1. Viewpack

[7 CANNONBURY LANE - NEW DWELLING - OB SUB FOR 10-05-20.PDF](#)
[30 CANNONBURY - NEW DWELLING - OB REV 10-05-20.PDF](#)
[8 CENTER STREET- FOR OB 10-05-20.PDF](#)

CERTIFICATE OF APPROPRIATENESS

HDC REVISION

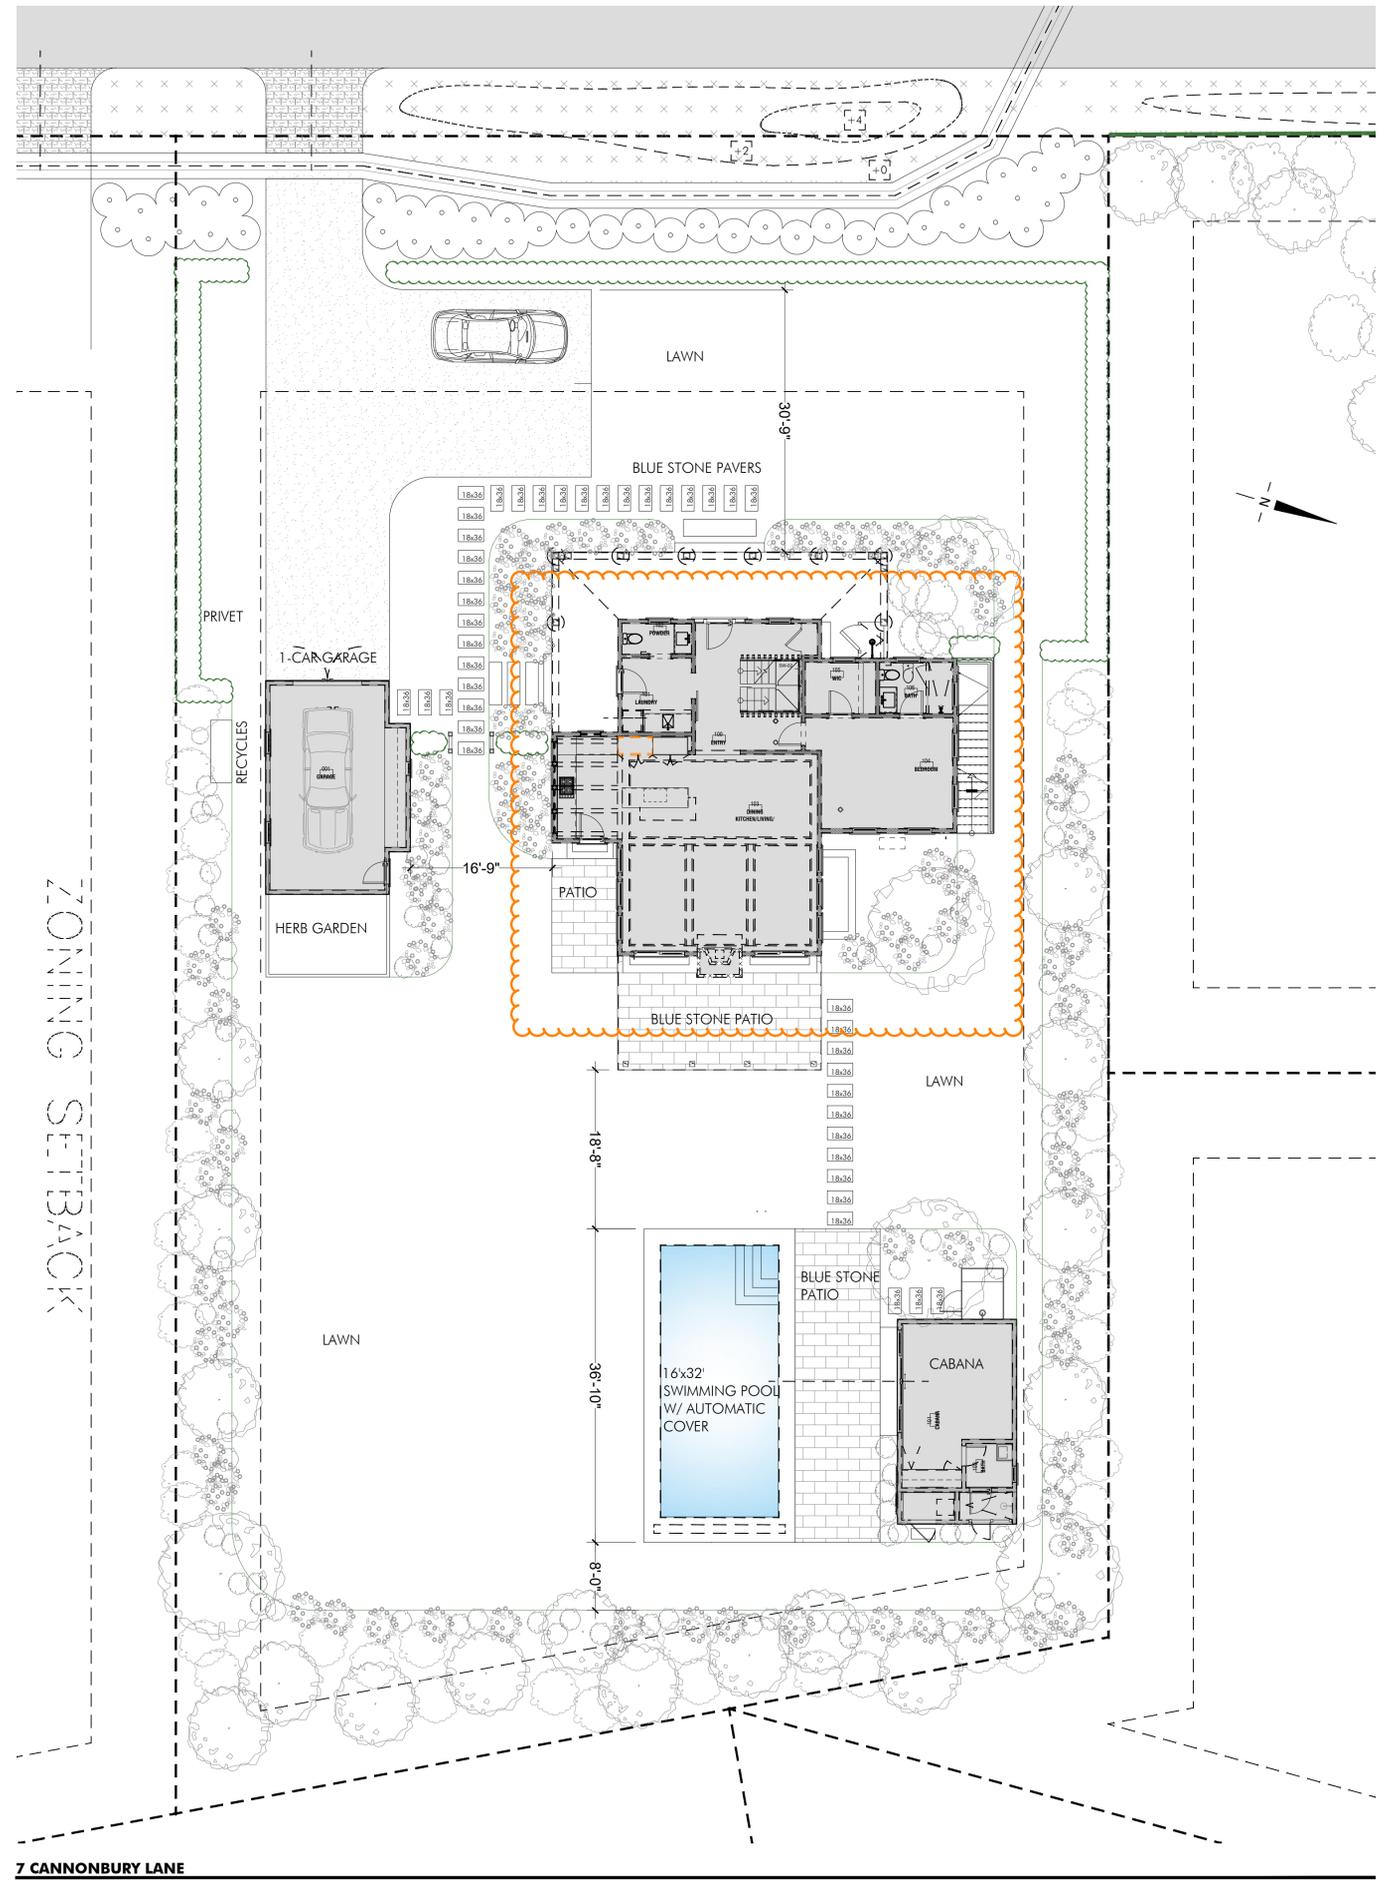
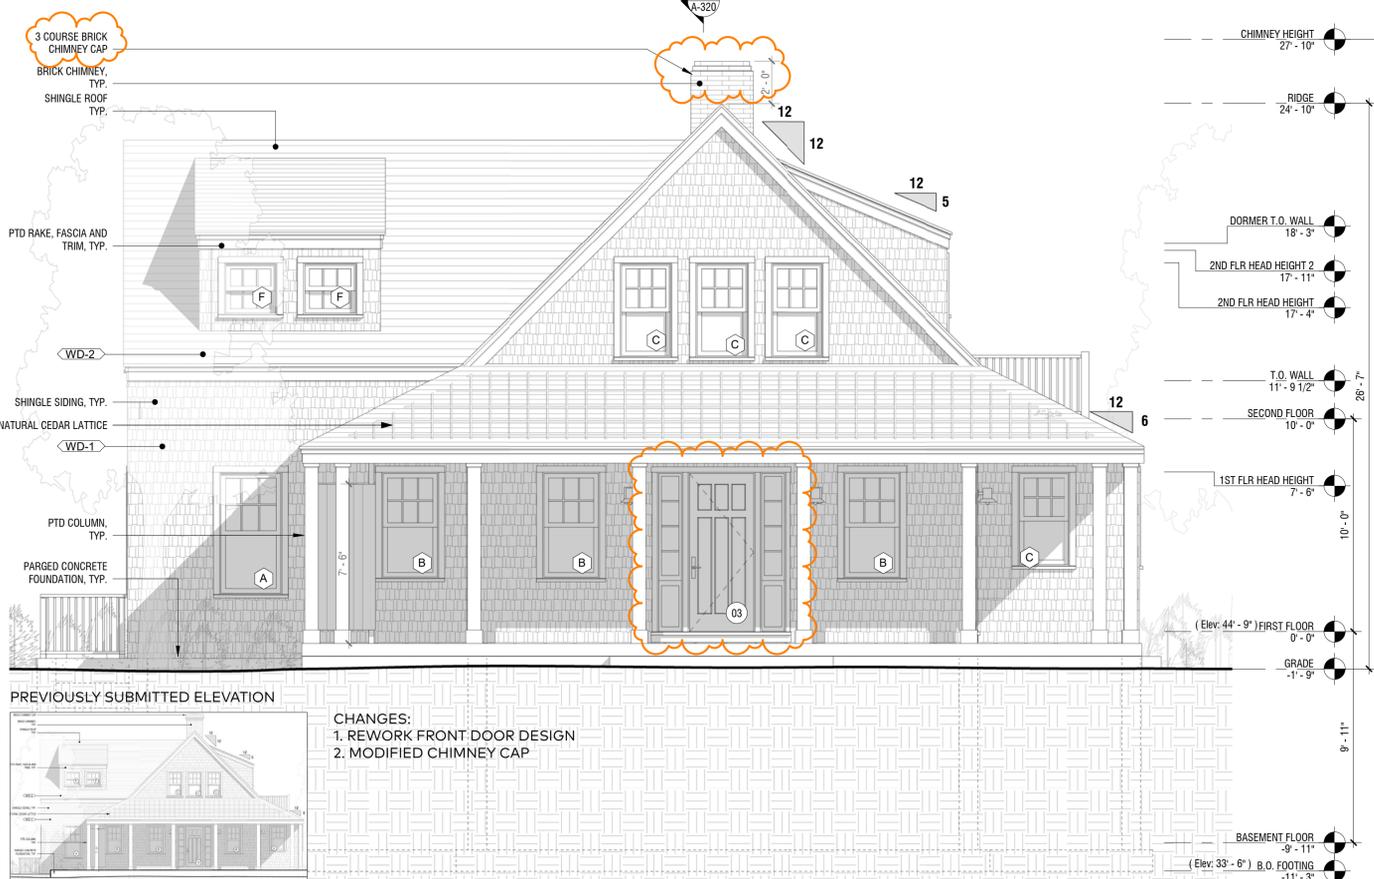
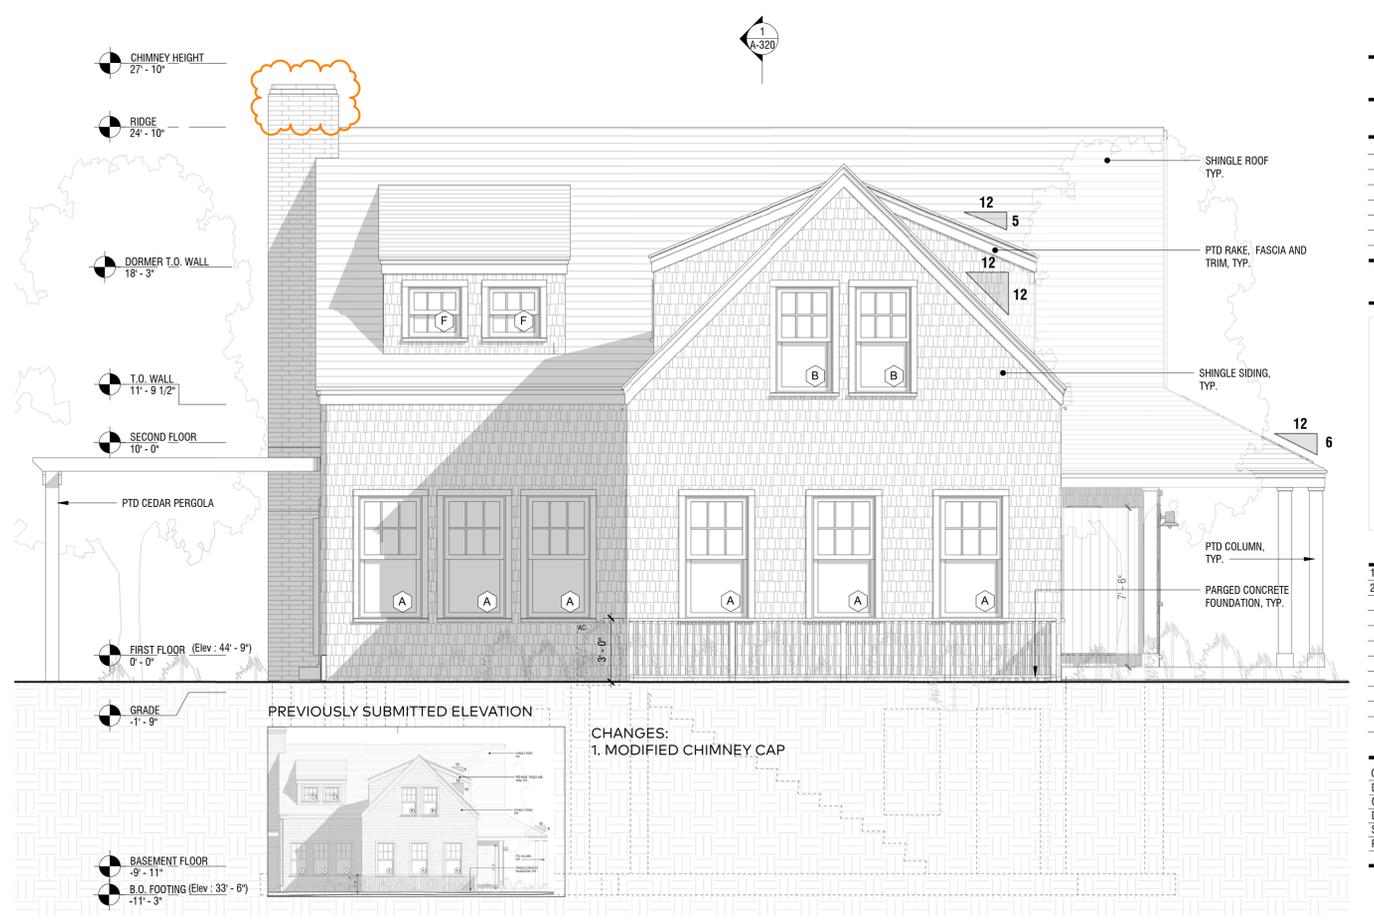
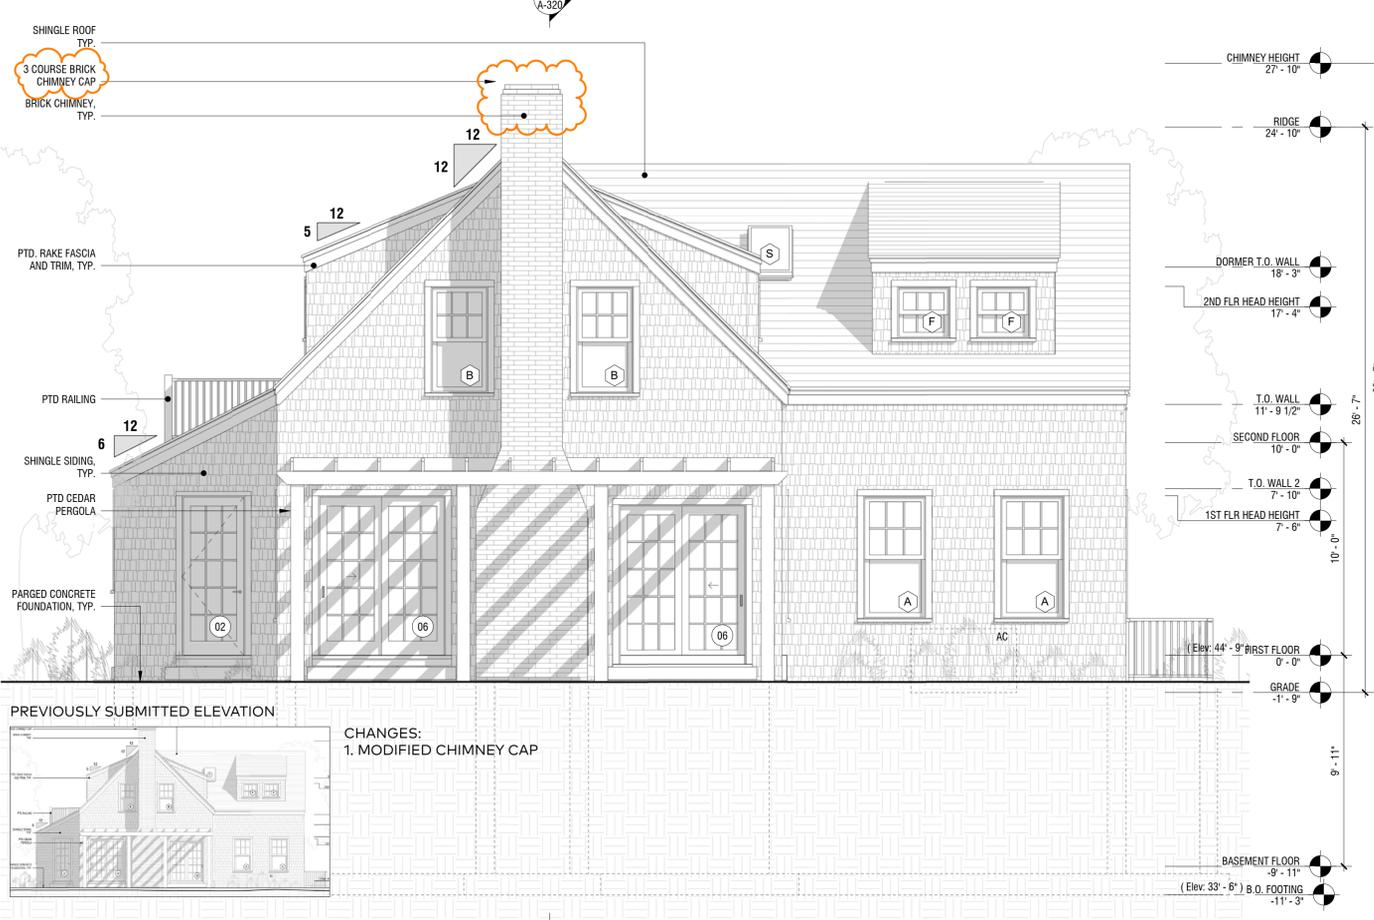
6. Cannonbury Ln Hold 1 08-1581	7 Cannonbury Lane	New dwelling	74/29	Workshop APD
Voting	Pohl, Coombs, McLaughlin, Camp, Oliver			
Alternates	Welch, Dutra			
Recused	None			
Documentation	Architectural elevation plans, site plan, photos, and advisory comments			
Representing	Michael Luft-Weissberg, Workshop APD			
Public	None			
Concerns (5:54)	<p>Luft-Weissberg – Presented project; module Eden Rose; white windows and trim with Cortland blue front door. Asserts the top of chimney is 29’7”; the roof is 26’6”.</p> <p>Backus – Read SAB comments: main entry with sidelights too formal; 2nd-floor deck and doors on front inappropriate; where roof meets wall looks truncated.</p> <p>Camp – Okay with the front door sidelights as long as the two bottom panels were wood. Agrees about the 2nd-floor deck and French door is out of place. This design is much more successful for this area. East elevation, the 2nd-floor French door should be a window. Chimneys should be corbelled in.</p> <p>Coombs – This is an improvement. The front door is too formal with the sidelights and triple panels. East elevation, this is 29 feet tall; too many ganged windows – the four ganged should be reduced to 2 windows aligned with the windows above; the triple ganged windows are pinched in and should be reduced to 2 windows. She thought “Sconset was trying to cap heights at 25 feet.</p> <p>Oliver – She likes this a lot; it’s more appropriate. Everyone should drive out there; there is a vast array of designs and sizes. Doesn’t believe Cannonbury will be a cluster of a few designs.</p> <p>McLaughlin – West elevation deck, can’t tell how large it is (68” deep).</p> <p>Pohl – From grade this is 26’7”. Agrees with SAB about the front door; the sidelights should have bottom panels; there is conflicting vocabulary with the cottage style door and sidelights. This design is more sensitive than the prior design.</p>

Motion	Motion to Hold for revisions. (Camp)			
Roll-call Vote	Carried //Coombs, Oliver, McLaughlin, Camp, and Pohl-aye		Certificate #
